Westinghouse  
Electric Corporation

NTD-NRC-94-4236  
DCP/NRC0162  
Docket No.: STN-52-003

SUBJECT: WESTINGHOUSE RESPONSES TO NRC REQUESTS FOR ADDITIONAL  
INFORMATION ON THE AP600

NTD-NRC-94-4236  
ATTACHMENT A  
AP600 RAI RESPONSES  
SUBMITTED JULY 25, 1994

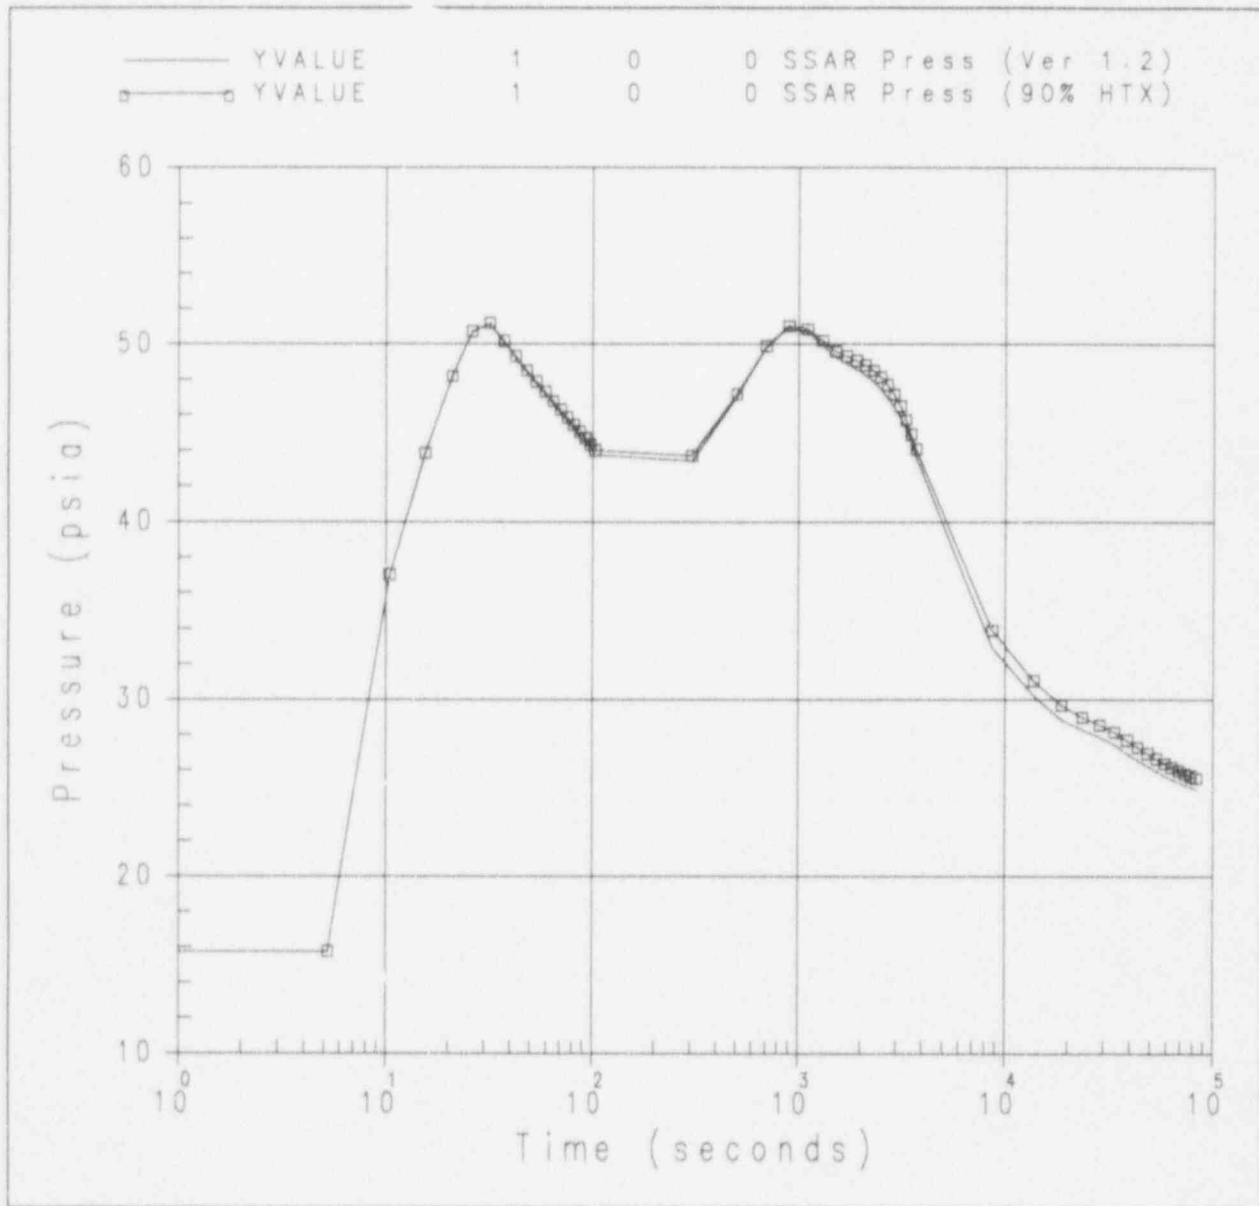
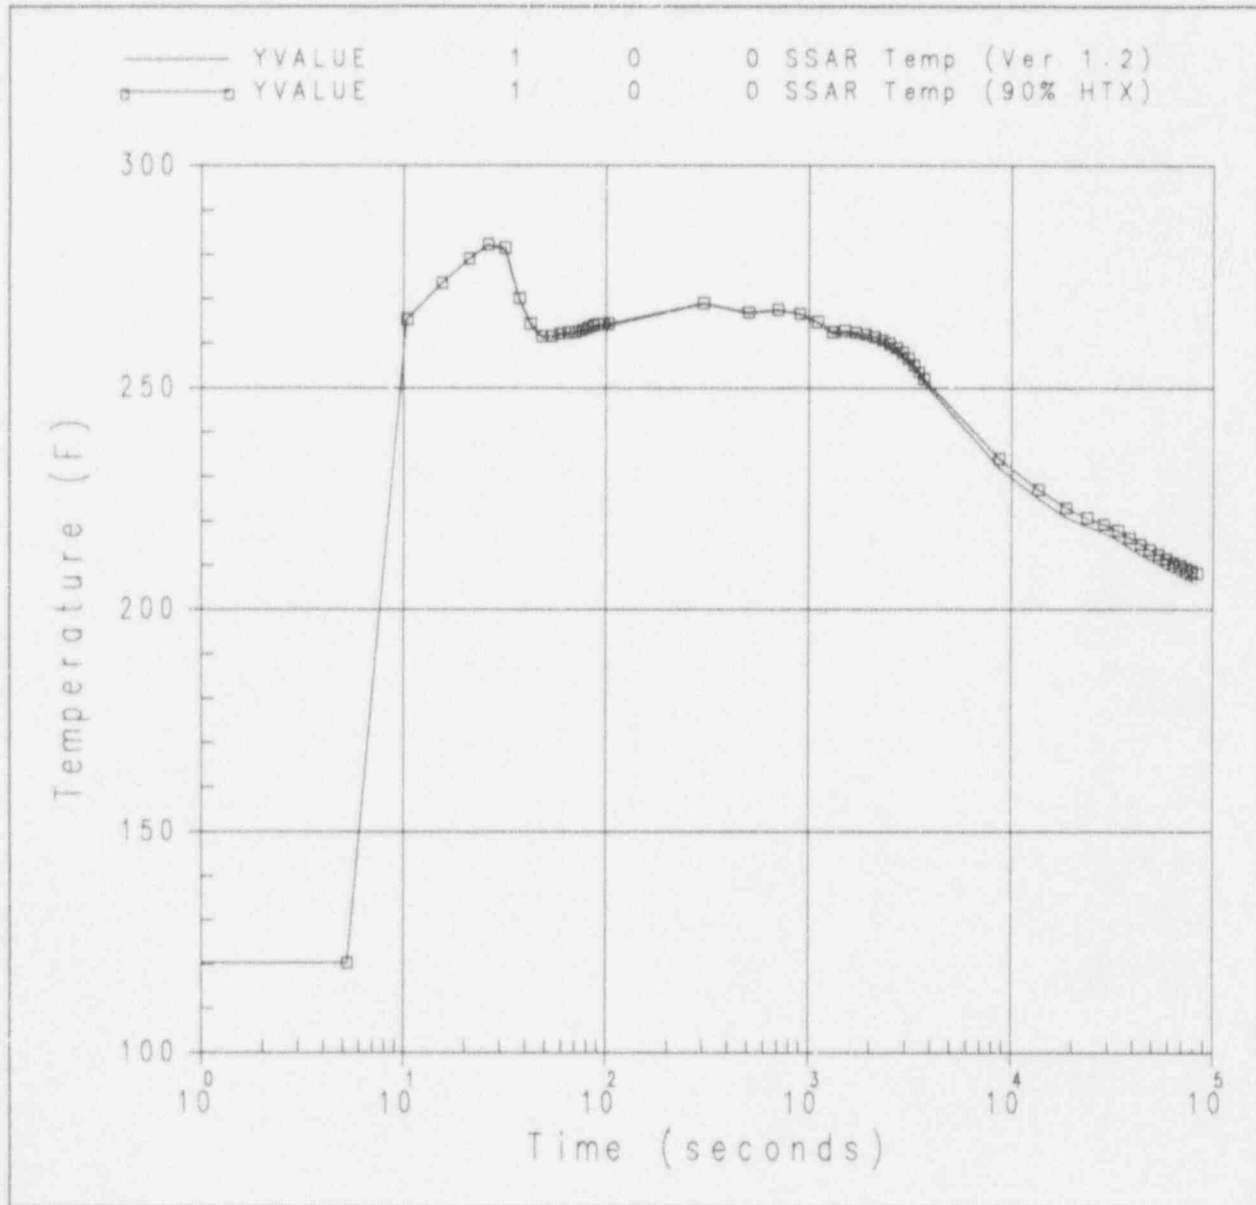
- a. What is Westinghouse's position relative to required margin between maximum calculated and design pressure? If none is considered, then how does Westinghouse ensure there will be no differences between the current design stage and the "as built" of the actual plant.
- b. Provide justification for using best-estimate heat transfer coefficients in DBA calculations. Provide an uncertainty analysis for the worst case DBA accident that takes these heat transfer coefficients into account.
- c. The staff understands that other parameters that are inputs to the DBA calculations are conservative, specifically boundary conditions and initial conditions such as input mass and energy release rates. Confirm this understanding.

- b. The heat transfer correlations used in the design basis analysis calculations are taken from open literature and applied via the Westinghouse-GOTHIC code. The free convection component of the heat transfer correlation is calculated using the McAdams correlation. The Colburn correlation is used for natural convection heat transfer that is better represented by a forced convection heat transfer coefficient due to higher steam/air velocities. These correlations are applied directly; however, there is the capability to apply heat transfer coefficient multipliers to the calculation. To demonstrate the sensitivity to an uncertainty of 10%, the limiting loss of coolant accident case was reanalyzed. The heat and mass transfer coefficients were reduced to 90% of the calculated value and the transient was rerun. The reduction in the heat transfer coefficient should not affect the blowdown peak pressure, but should cause the containment pressure and temperature to increase later in the transient.

The containment pressure and temperature response calculated with the reduced heat transfer coefficients has been plotted and compared with the limiting loss of coolant accident case. The peak containment pressure (which occurs at the end of blowdown) increased by 0.05 psi and the containment pressure at 24 hours increased by 0.6 psi (and is still less than half the containment design pressure).
